Access Compliance Report

Public Rights-of-Way

(Curb Ramps)

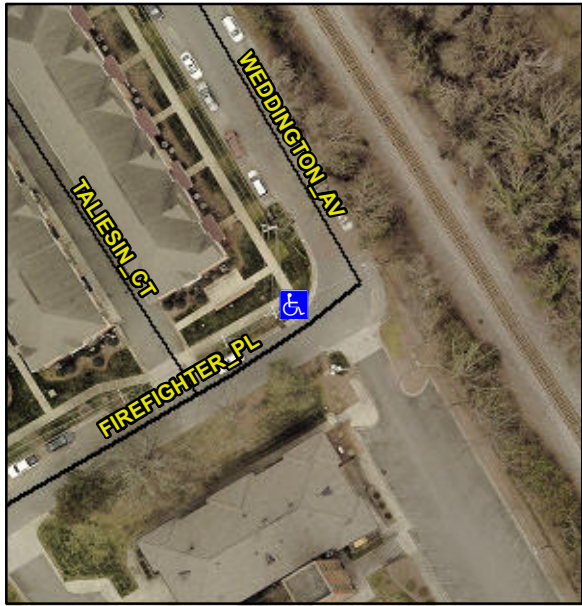
Intersection ID: 10026612		Main Street: FIREFIGHTER_PL		Cross Street: N/A		Location:		W			
ADA ID: A9020C4843A8		Ramp Type: Directional1		Initial Pass/Fail: Fail		Overall Compliance: No		Severity Score: 12.5			
Codes/Mitigation Info/Possible Solution				Field Measurements/Component Compliance							
				Possible Solutions:		Compliance		Description		Data	
				Remove & Replace Entire Ramp.		N/A		Ramp Length (in)		65.0	
Surveyor Notes:				N/A		Yes		Ramp Width (in)		60.0	
						No		Ramp Slope (%)		9.0	
PROW/ADA:				R304.2.2		Yes		Ramp XSlope (%)		1.7	
						N/A		Flare Type LT		N/A	
						N/A		Flare Slope LT (%)		N/A	
						N/A		Flare Traversable LT?		N/A	
						N/A		Landing Length (in)		0.0	
						N/A		Landing Width (in)		0.0	
						N/A		Landing Slope (%)		0.0	
						N/A		Landing X Slope (%)		0.0	
						N/A		Landing Curb? (Y/N)		N/A	
						N/A		Shared Landing?		N/A	
						N/A		Gutter Ponding?		0.0	
						N/A		Gutter Lip Ht (in)		0.0

N/A		Painted X Walk1?		No	
						X Walk 1 Direction		To SE			
						X Walk 1 Width (in)		N/A		Clear Space?	
						X Walk 1 Slope (%)		1.3		Clear Space to XWalk (in)	
						X Walk 1 X Slope (%)		1.3		Storm Grate/Utility Hazard?	
						N/A		Ramp inside XWalk1?		N/A	
						N/A		Any Obstructions?		N/A	
						Obstruction Type		Yes			
						N/A		Surface Condition? (G/P)		Good	
						N/A		Curb Slope (%)		11.6	
Street 1 Name		FIREFIGHTER PL									
Stop Condition-Street 1		None									
Street 2 Name		N/A									
Stop Condition-Street 2		N/A									
Total Cost:		\$		1600.00

Remove & Replace Entire Ramp.
